May 26, 2021

Reference No. 11218340

**Re: Geotechnical and Slope Stability Review  
Proposed Residential Development - 2L49 Lakeshore Road, Wainfleet, Ontario**

Figure 5  
 Cross-Section A-A  
 Global Stability Static Analyses  
 Proposed Residential Redevelopment  
 2L49 Lakeshore Road, Wainfleet, Ontario

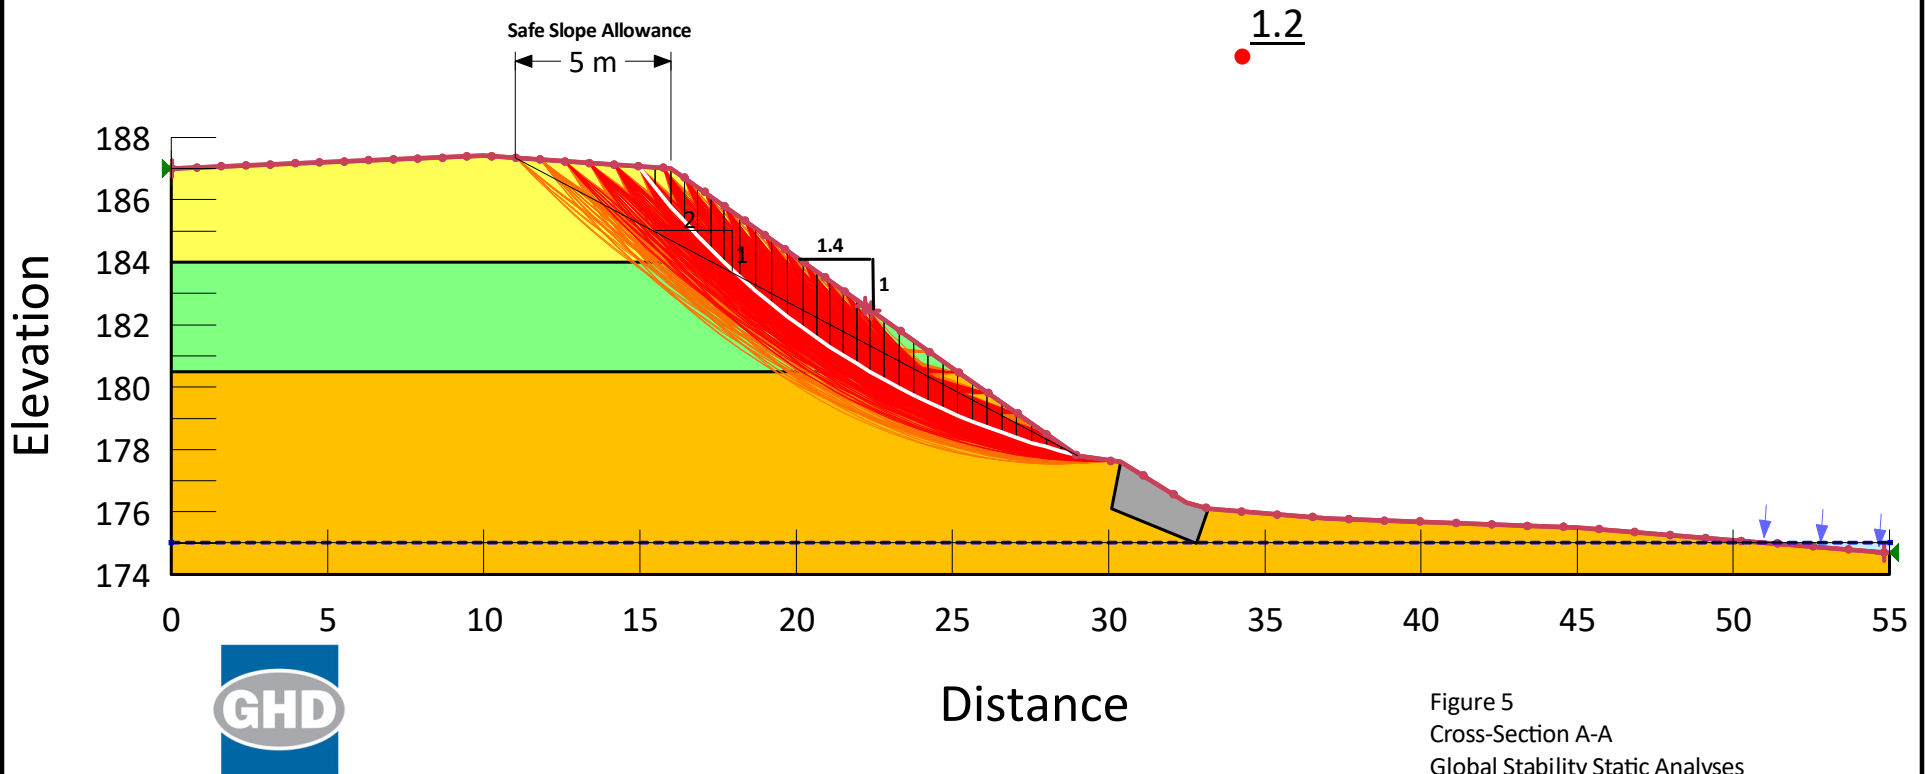
| Analysis                         | Cross-Section/<br>Figure | Gradient<br>(H:V) | Factor of Safety    |            | Stable Slope<br>setback<br>Allowance (m) <sup>(1)</sup> |
|----------------------------------|--------------------------|-------------------|---------------------|------------|---|
| Global Stability - Static        | A-A Figure 5             | 1.4:1             | 1.5                 | 1.2        | 5.0   |

- Analyses completed show factors of safety less than 1.5 under static conditions. A factor of safety of 1.5 under static conditions was achieved at 5 m and 2 m, as measured from the top of the slope for the 1.4H:1V and 2H:1V slopes, respectively. A slope stability analysis was not completed for the west slope. Due to the similar steepness of the slope to Section A-A, it is recommended that a Stable Top of Slope setback allowance of 5 m should be used along the west side slope.
- Using the results of analyses discussed in the bullet item above, the recommended long term Stable Top of Slope allowance is shown on Figure 9.

growth will reduce the slope stability. As an alternative, the long-term stable top of slope can be considered at an offset distance of 2 m and 5 m inland from the existing top of slope at cross-sections A-A and D-D, respectively, which meets the AMEC 2H:1V slope criterion.

Figure 6  
 Cross-Section A-A  
 Global Stability Pseudo-Static Analyses  
 Proposed Residential Redevelopment  
 2L49 Lakeshore Road, Wainfleet, Ontario

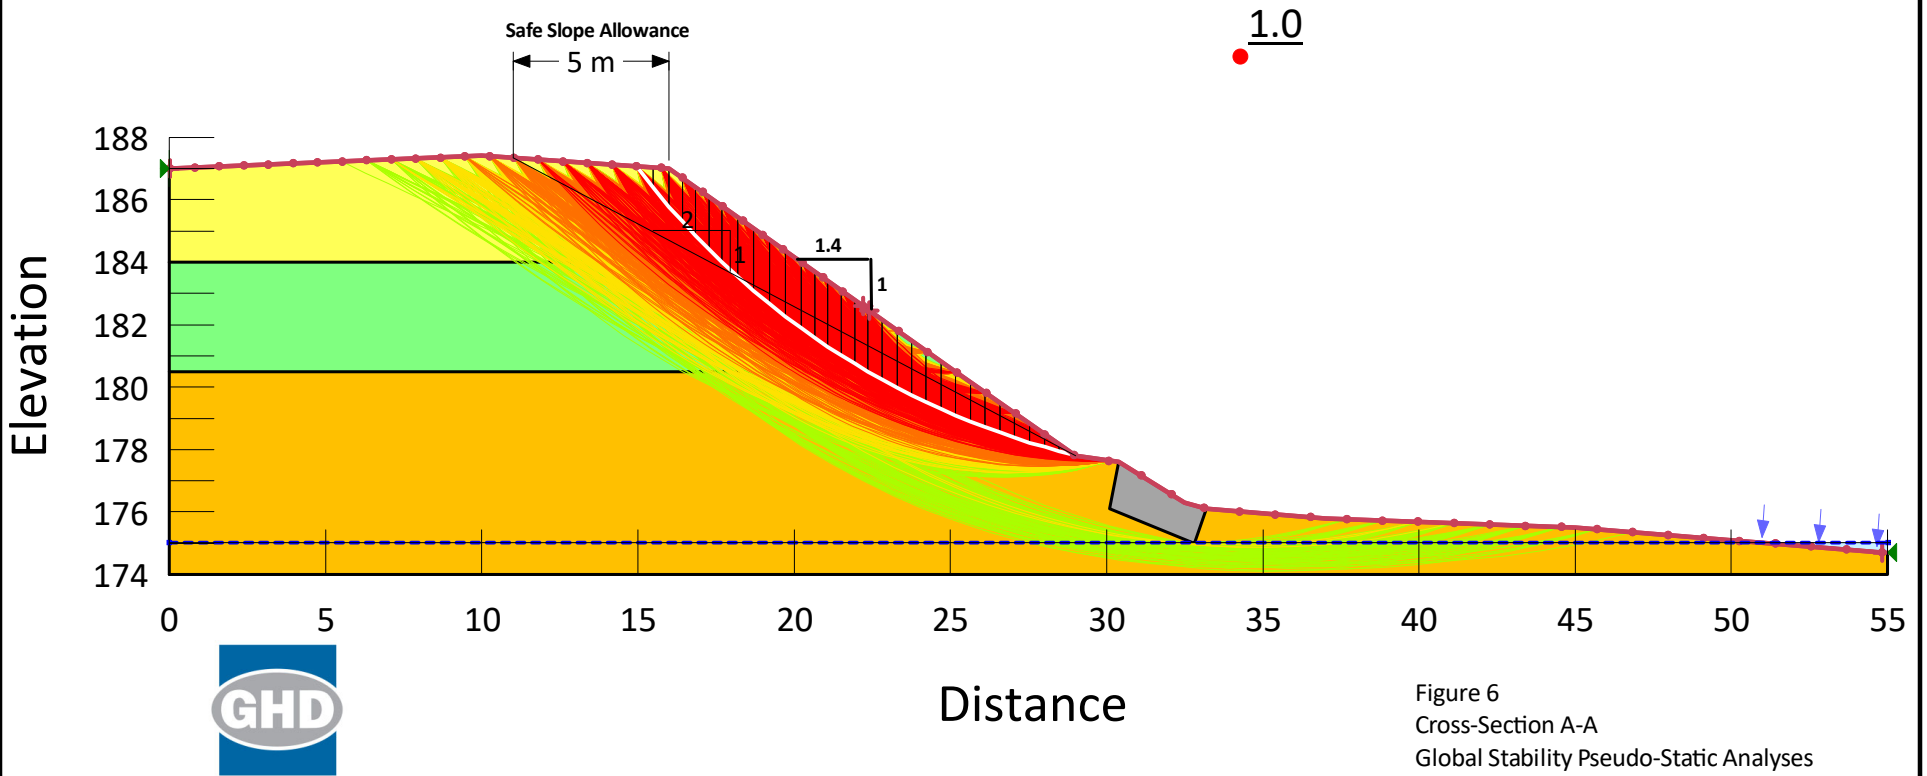
| Analysis                         | Cross-Section/<br>Figure | Gradient<br>(H:V) | Factor of Safety    |            | Stable Slope<br>setback<br>Allowance (m) <sup>(1)</sup> |
|----------------------------------|--------------------------|-------------------|---------------------|------------|---|
| Global stability - Pseudo Static | A-A Figure 6             | 1.4:1             | 1.0                 | 1.0        | 2.0   |

Figure 7  
 Cross-Section D-D  
 Global Stability Static Analyses  
 Proposed Residential Redevelopment  
 2L49 Lakeshore Road, Wainfleet, Ontario  
 11218340

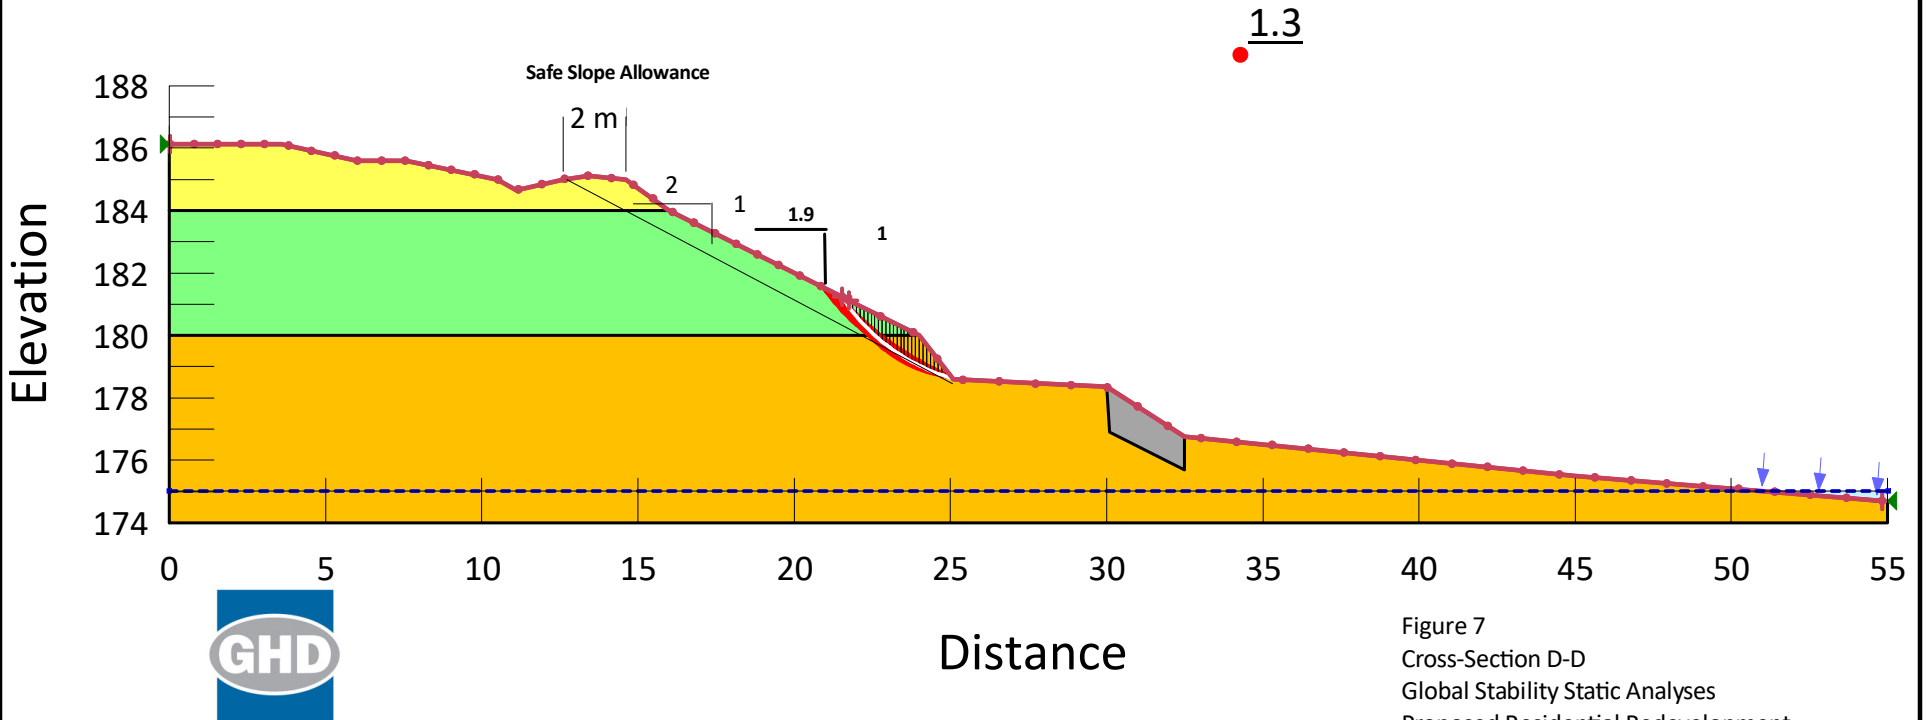
| Analysis                         | Cross-Section/<br>Figure | Gradient<br>(H:V) | Factor of Safety    |            | Stable Slope<br>setback<br>Allowance (m) <sup>(1)</sup> |
|----------------------------------|--------------------------|-------------------|---------------------|------------|---|
| Global Stability - Static        | D-D Figure 7             | 2.0:1             | 1.5                 | 1.3        | 2.0   |

Figure 8  
 Cross-Section D-D  
 Global Stability Pseudo-Static Analyses  
 Proposed Residential Redevelopment  
 2L49 Lakeshore Road, Wainfleet, Ontario  
 11218340

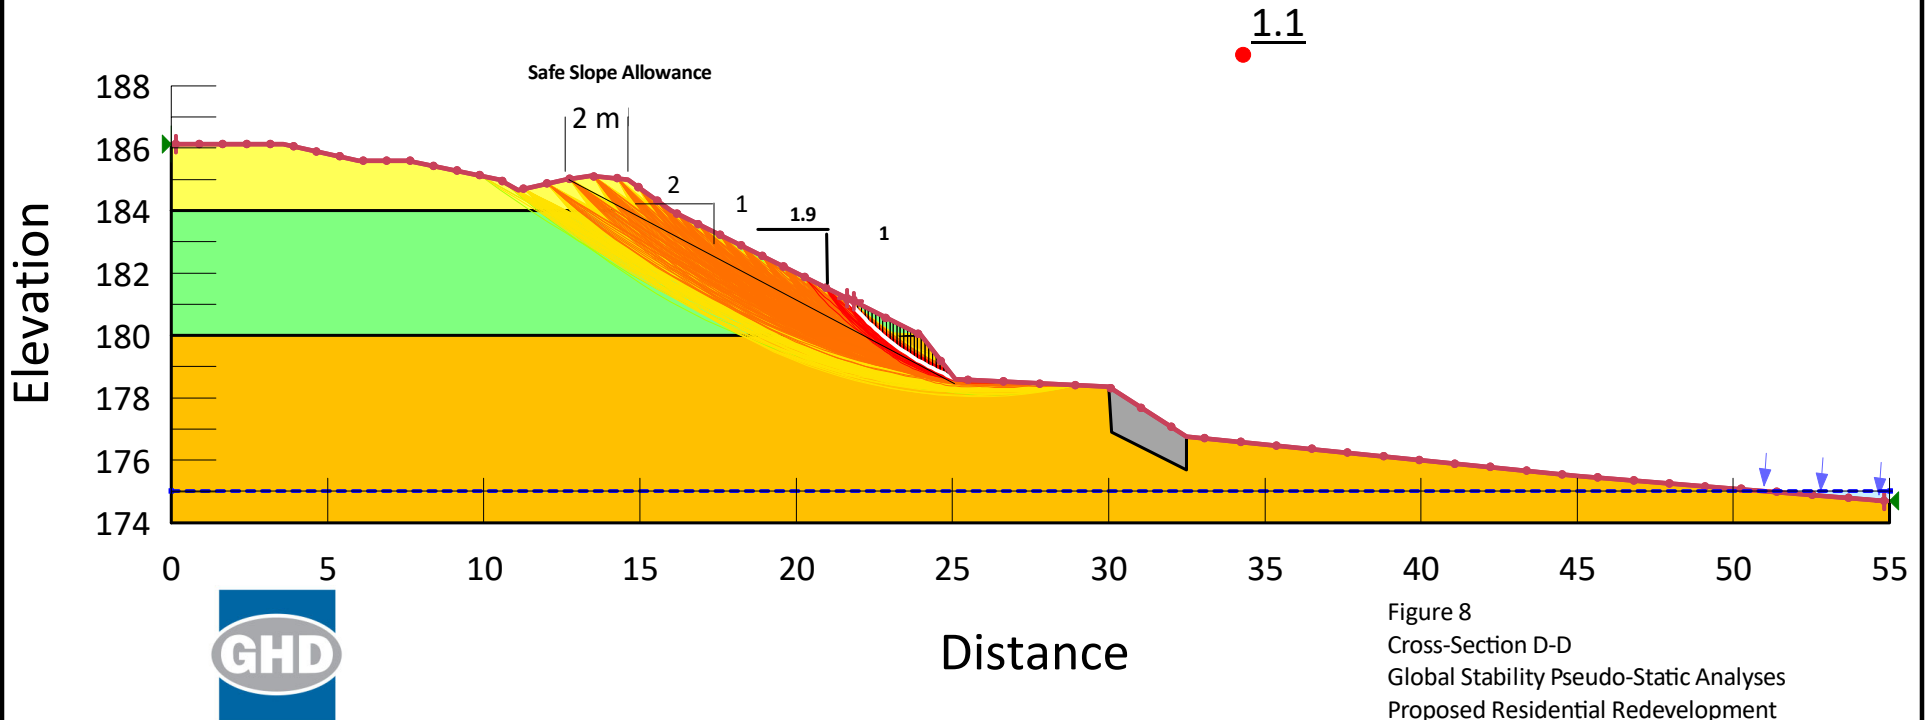
| Analysis                         | Cross-Section/<br>Figure | Gradient<br>(H:V) | Factor of Safety    |            | Stable Slope<br>setback<br>Allowance (m) <sup>(1)</sup> |
|----------------------------------|--------------------------|-------------------|---------------------|------------|---|
| Global stability - Pseudo Static | D-D Figure 8             | 2.0:1             | 1.0                 | 1.1        | 1.83  |
